Re: Port Authority of Allegheny County
East Busway Rock Slope Stabilization Study
Geotechnical Engineering Report

ATTACHMENT 1
FIELD RECONNAISSANCE PLANS AND PHOTOGRAPHS

PORT AUTHORITY OF ALLEGHENY COUNTY
 PITTSBURGH PENNSYLVANIA
 EAST BUSWAY
 PLAN
 STA. 246+50 TO STA. 252+50
 MICHAEL BAKER, JR., INC.
 CONSULTING ENGINEERS BEAVER, PENNSYLVANIA

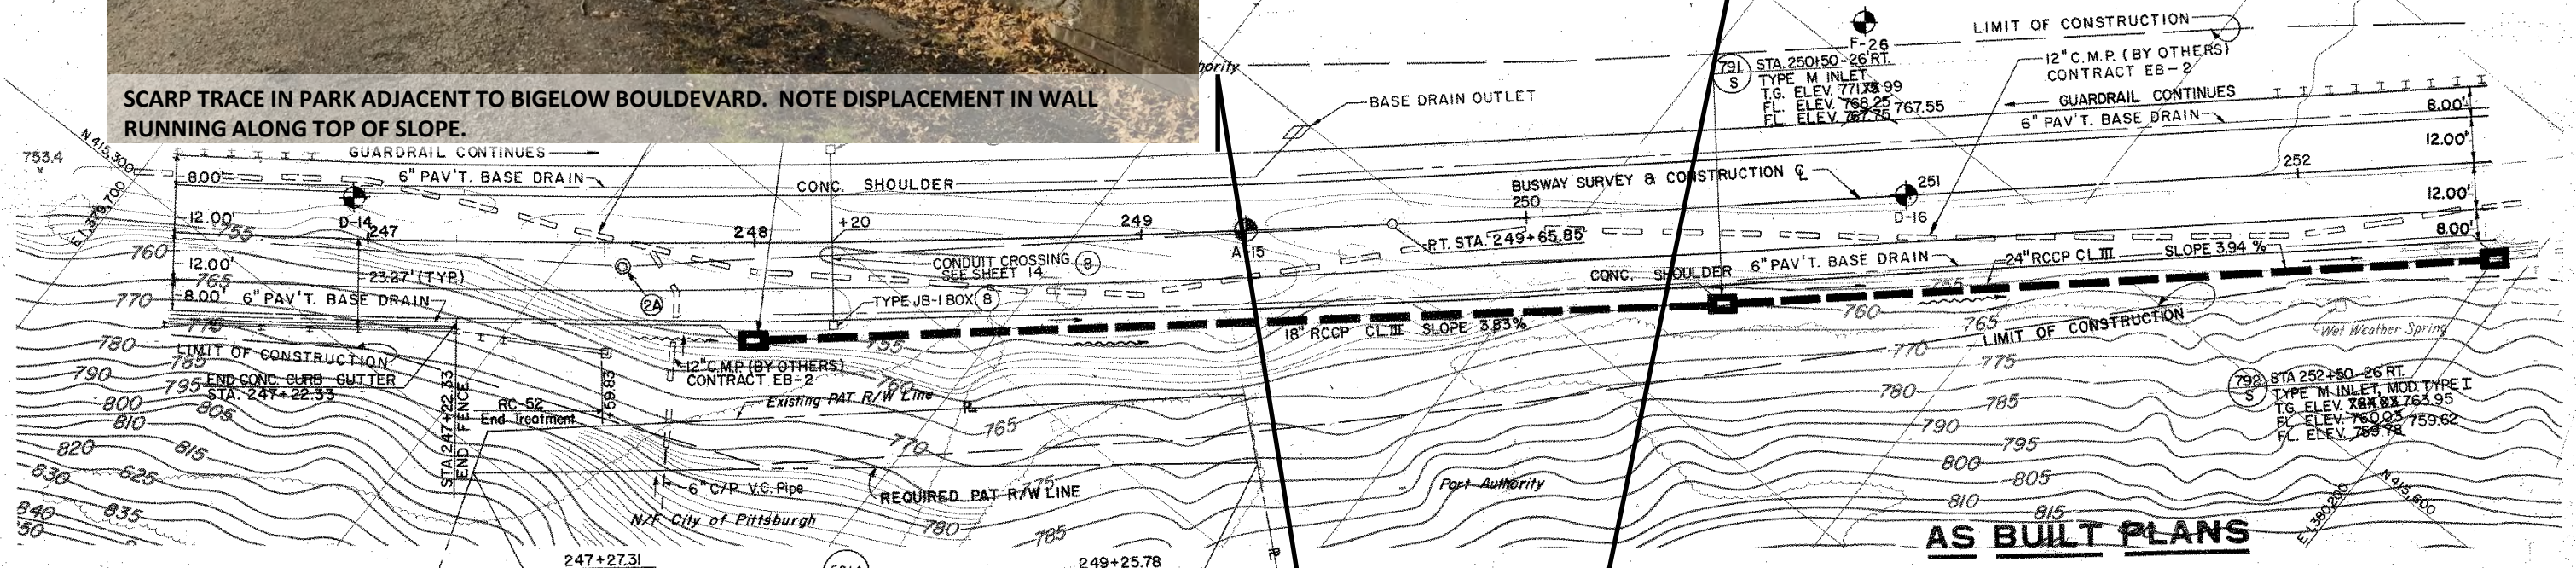
SCARP TRACE IN PARK ADJACENT TO BIGELOW BOULEVARD. NOTE DISPLACEMENT IN WALL RUNNING ALONG TOP OF SLOPE.

SCARP TRACE IN PARK ADJACENT TO BIGELOW BOULEVARD.
